# WINDERMERE PRELIMINARY PLAN

## E 1/2 OF SECTION 29, T13S, R65W OF THE 6TH P.M. EL PASO COUNTY, COLORADO

# prelim plan V\_3 redlines.pdf Markup Summary 12-10-2020

**PP06**

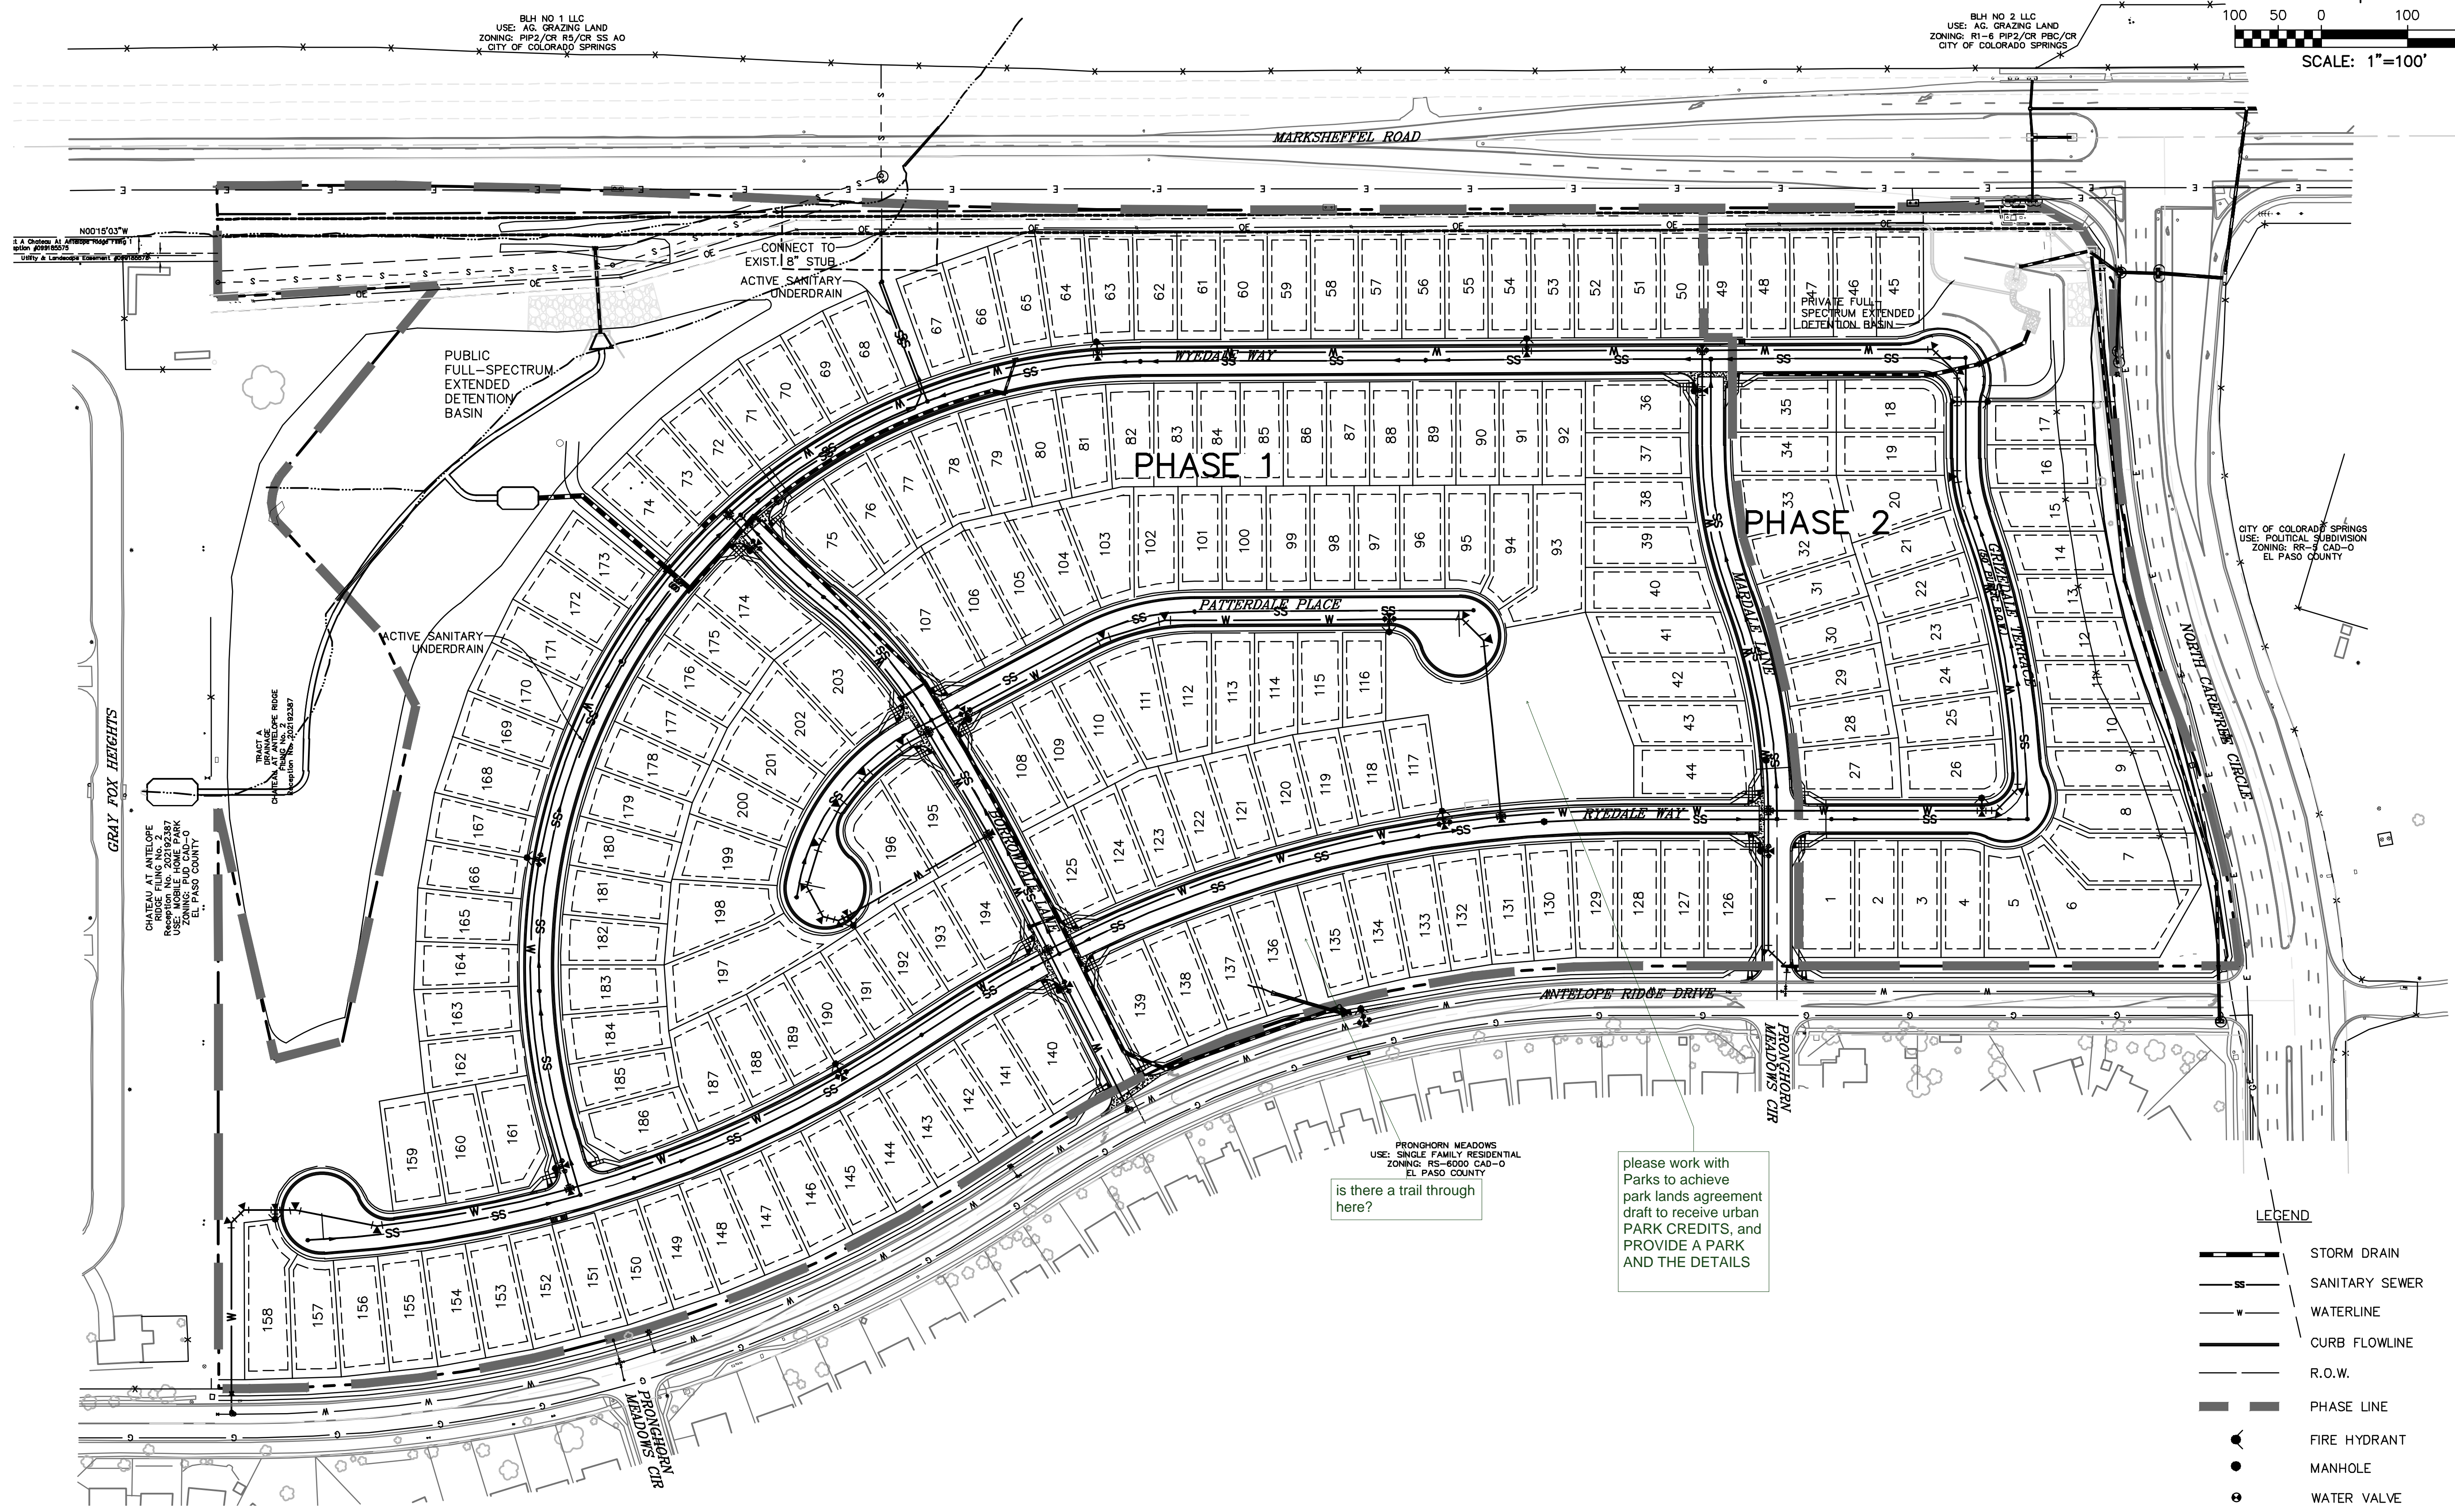
please work with Parks to achieve park lands agreement draft to receive urban PARK CREDITS, and PROVIDE A PARK AND THE DETAILS

please work with Parks to achieve park lands agreement draft to receive urban PARK CREDITS, and PROVIDE A PARK AND THE DETAILS

is there a trail through here?

**PP07**

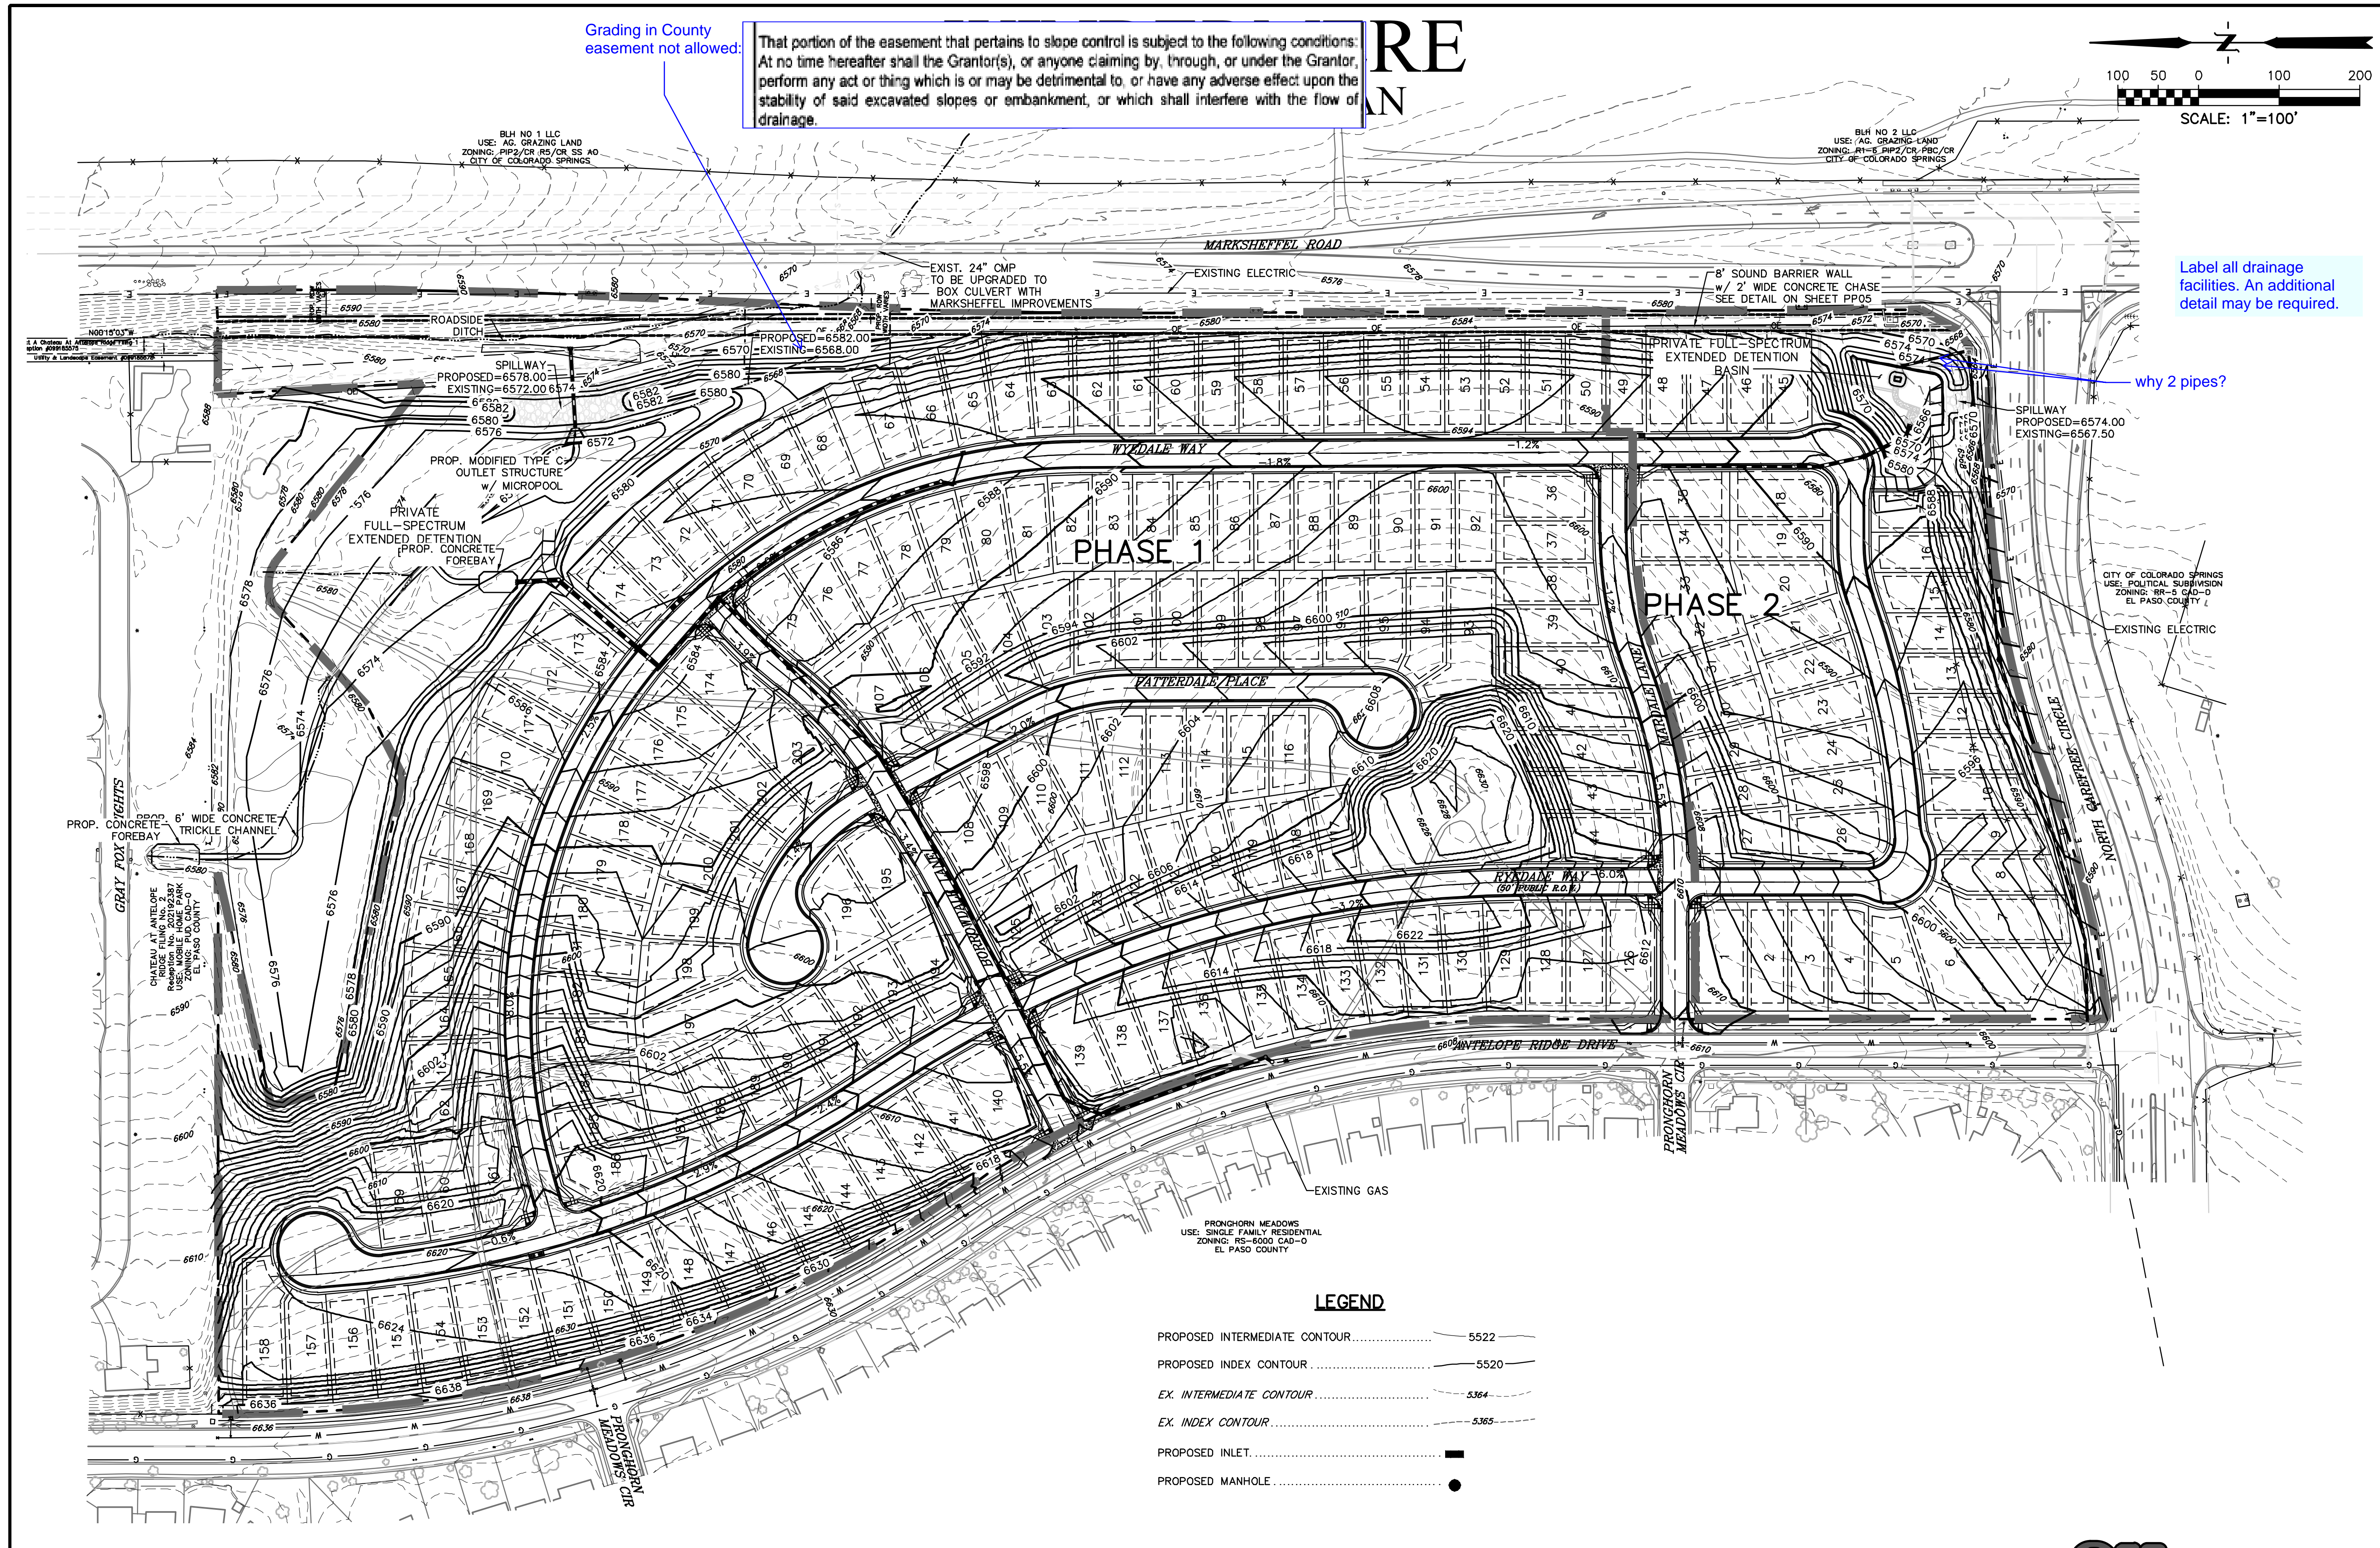
Grading in County easement not allowed:

That portion of the easement that pertains to slope control is subject to the following conditions: At no time hereafter shall the Grantor(s), or anyone claiming by, through, or under the Grantor, perform any act or thing which is or may be detrimental to, or have any adverse effect upon the stability of said excavated slopes or embankment, or which shall interfere with the flow of drainage.

Label all drainage facilities. An additional detail may be required.

why 2 pipes?

Grading in County easement not allowed:

why 2 pipes?

Label all drainage facilities. An additional detail may be required.

# PP08

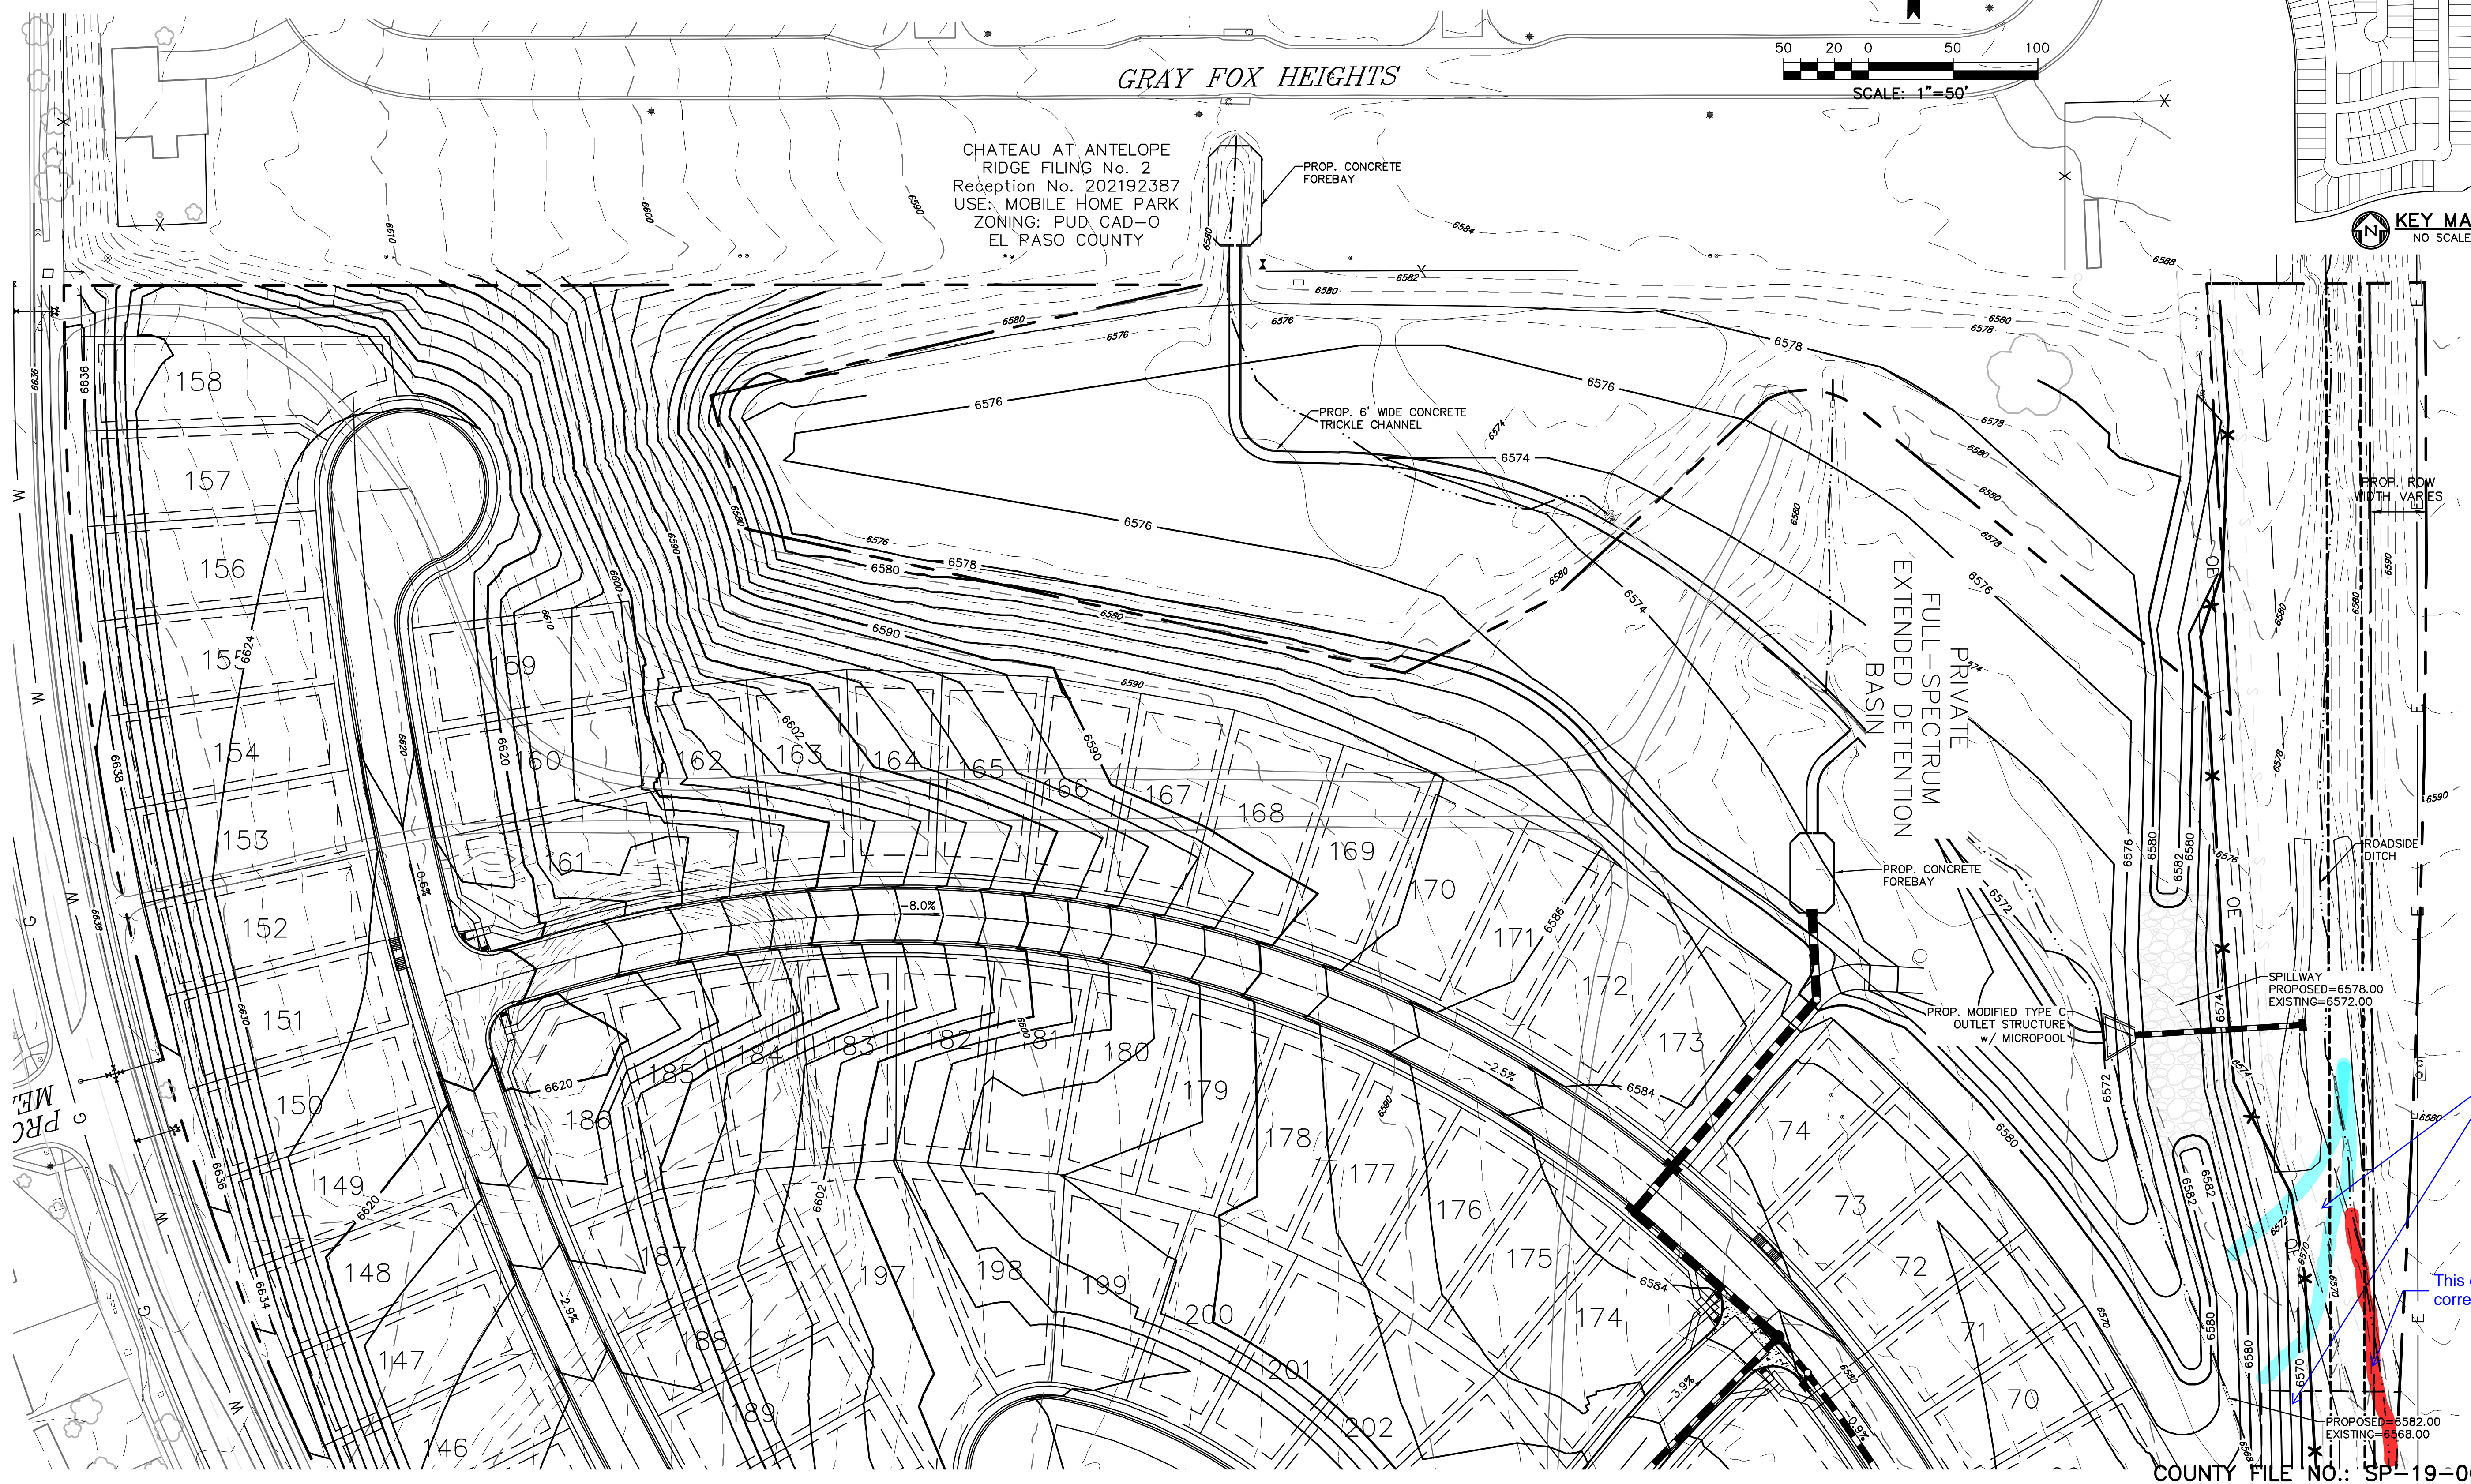
PREPARED UNDER MY DIRECT SUPERVISION FOR AND ON BEHALF OF  
**DREXEL, BARRELL & CO.**  
 Show existing flowpath. Provide a design that conveys all flows properly. No grading in County easement.

This does not look correct

This does not look correct

Show existing flowpath. Provide a design that conveys all flows properly. No grading in County easement.
